Docket Item # 16
BAR CASE # 2007-0158

BAR Meeting
September 5, 2007

ISSUE: Additions and alterations
APPLICANT: Mark & Ann Kington by Belinda Reeder
LOCATION: 617/619 S. Lee Street
ZONE: RM/Residential

Figure 2 - Proposed site plan

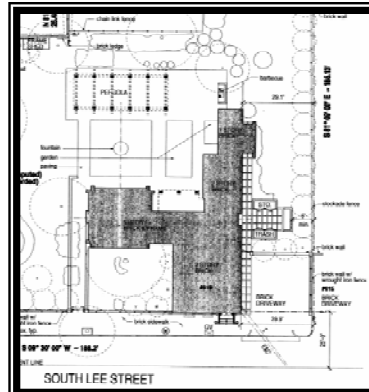
On the other hand, Staff does have significant concerns about the proposed living room addition on the south side of the house. Although set back from the front of the historic main block by 28 feet, it will be considerably more visible than the existing kitchen wing. As proposed, it is at least 5 feet higher at its peak than the existing wing. Although brick, it is proposed to be painted white, which will enhance its visibility. The visibility of the proposed new wing requires that it be viewed with a higher level of scrutiny than other aspects of the project.

There is much to appreciate about the proposed design: the way the wing is held off the historic main block by the smaller connector, the articulation of the 28 foot wide facades of the new wing and the attempt at blending of traditional materials and forms with modern design elements. However, Staff is concerned that the addition is still not sufficiently compatible with the historic house. The proportions and massing of the addition seems to clash with the historic house. At 28 feet wide, it is the same width as the main block. The projecting gable ends were intended to

break up the width of the facades, but may actually contribute to its horizontal feel. The addition seems squat in relation to the elegant verticality of the historic house. This is not to propose that the addition should be taller. The addition must be both subservient to the historic main block and compatible with it in its proportions. As its current height is already half that of the historic house, the addition should not be any taller. Moreover, Staff understands that the height of the addition has already been reduced in response to concerns expressed by the easement holder. It may be that the width of the east elevation must also be reduced to achieve a more harmonious form. While appreciating the intent to distinguish the new construction from the old by utilizing modern design elements, Staff is concerned that the effort requires further refinement on the front façade of the addition. The addition should relate more closely to the front façade, without mimicking it. The windows on the front of the addition contrast too strongly with the finely detailed and highly regular federal fenestration of the main block. In addition, the solid to void relationship of the addition seems to be less than compatible with the historic façade. Lastly, the portion of the breezeway that projects above the connector appears awkward with its flat roof and off-center windows. It may be that this section will not be visible from the public right-of-way, something that could be demonstrated through sightline drawings or other means.

STAFF RECOMMENDATION, SEPTEMBER 5, 2007: Staff recommends restudy of the new living room addition and approval of all other alterations and additions with the following conditions:

Staff recommends restudy of the new living room addition and approval of all other alterations and additions with the following conditions:
